Re: Contract N62470-89-D-4814
Navy CLEAN, District III
Contract Task Order (CTO) 0160
Response to Comments
Draft Final RI/FS Project Plans for Operable Unit No. 7
MCB Camp Lejeune, North Carolina

Attachment A
Navy Environmental Health Center Comments and
Responses on the Draft Final RI/FS Project Plans
for Sites 1, 28, and 30 (Operable Unit No. 7)

**Response to Comments Submitted by LANTDIV
on the Draft Final RI/FS Project Plans for Sites 1, 28, and 30
(Operable Unit No. 7),
MCB Camp Lejeune, North Carolina
Comment Letter by Mr. William Mullen, P.G.,
Received by Baker Environmental, Inc. via Fax on 12-6-93**

FIGURE 5-1
 TYPICAL SHALLOW AND DEEP ABOVE GRADE TYPE II GROUNDWATER
 MONITORING WELL CONSTRUCTION DIAGRAM
 SITES 1, 28, AND 30

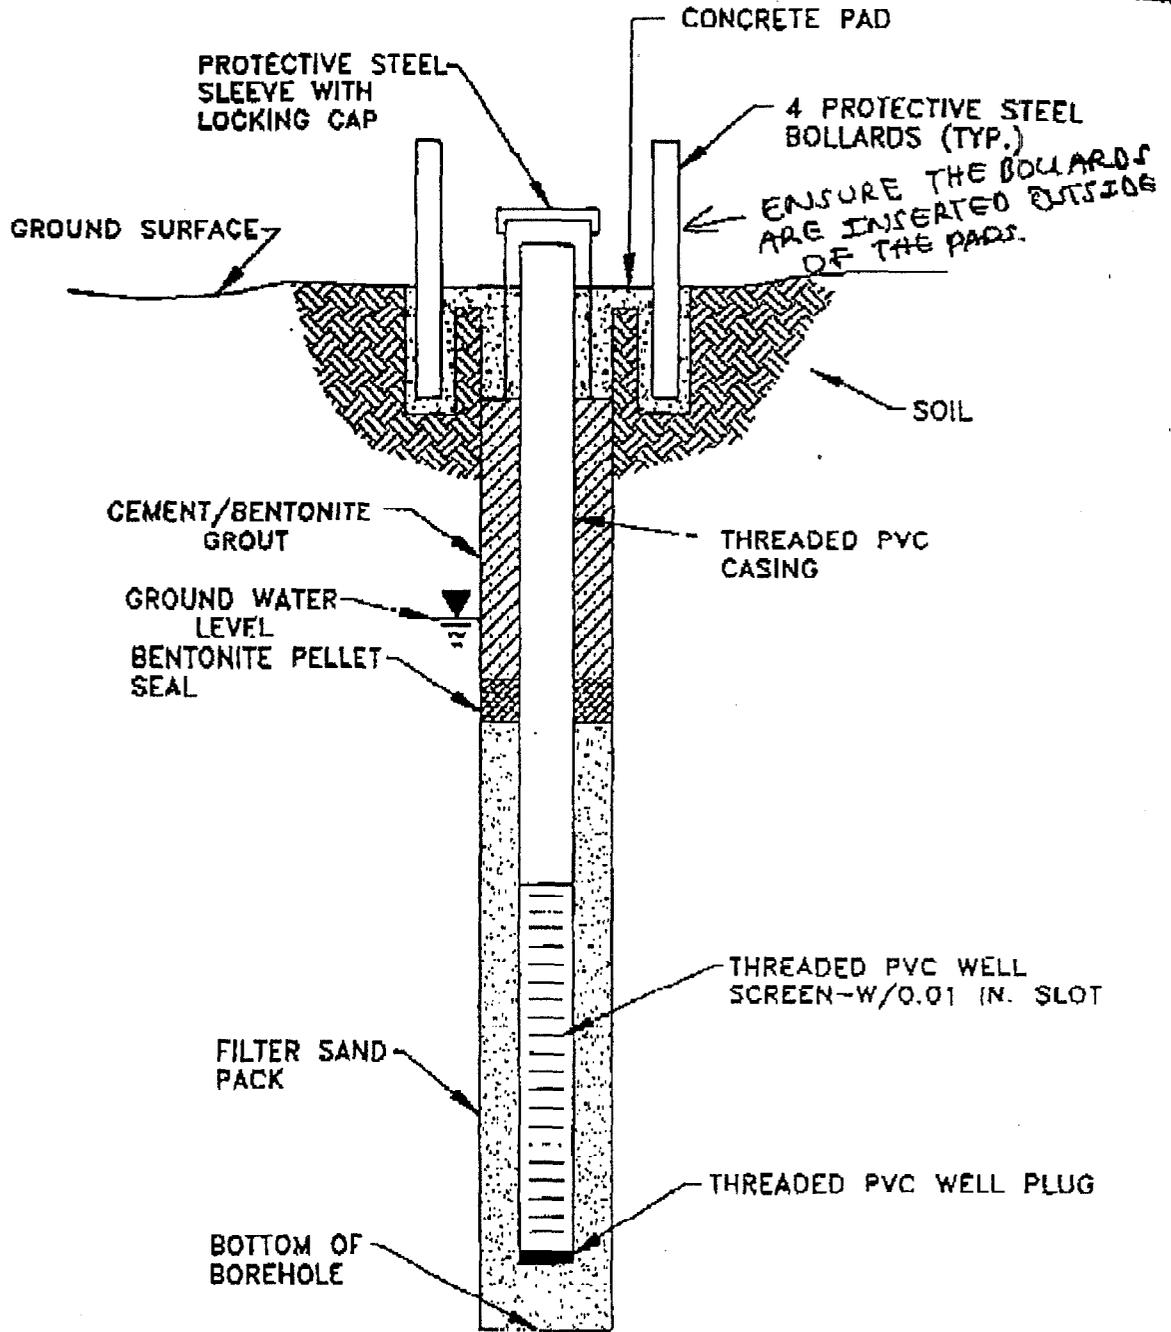
COMMENTS: ENCLOSED ARE COMMENTS FROM THE OU # 10 RI/FS HASP, SAP, AND WORK PLAN. IN ADDITION, COMMENTS FROM THE OU # 7 RI/FS SAP ARE ENCLOSED AS WELL. WE HAVE REVIEWED THE OU # 7 RI/FS HASP AND WORK PLAN AND HAVE NO COMMENTS. - THANKS - WALT.

- 1) The title "Field Sampling and Analysis Plan" will be added to the spine of the document.
- 2) A sentence will be added in the section describing well construction details that states that the four protective bollards will be installed outside the concrete pads. This information will also be added to Figures 5-1 and 5-2.
